CAIRO
Appl. No. 10/720,172
August 8, 2006

AMENDMENTS TO THE DRAWINGS

REMARKS/ARGUMENTS

Fig. 1 (PRIOR ART)

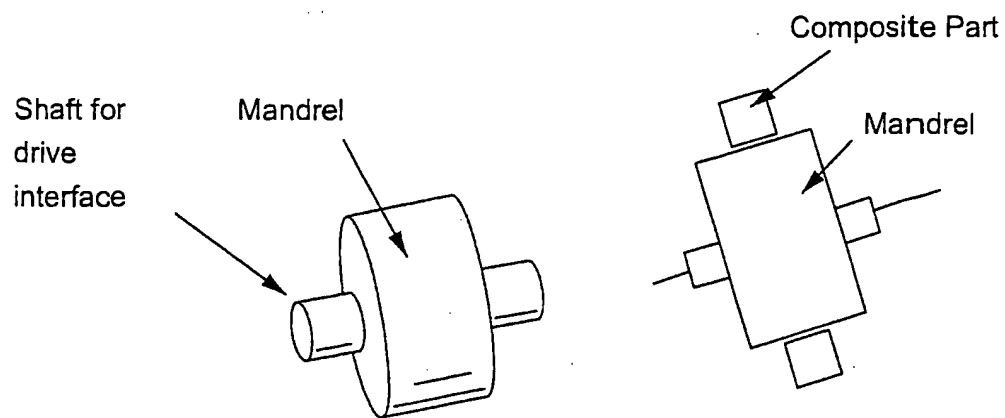
The attached sheet of drawings includes changes to Fig. 1. This sheet, which includes Figs. 1-3, replaces the original sheet including Figs. 1-3. In Figure 1, a "Prior Art" label has been added.

With reference to the Office Action, in the drawing amendment herein, Fig. 1 is amended to include a "prior art" legend. Withdrawal of the objection is requested.
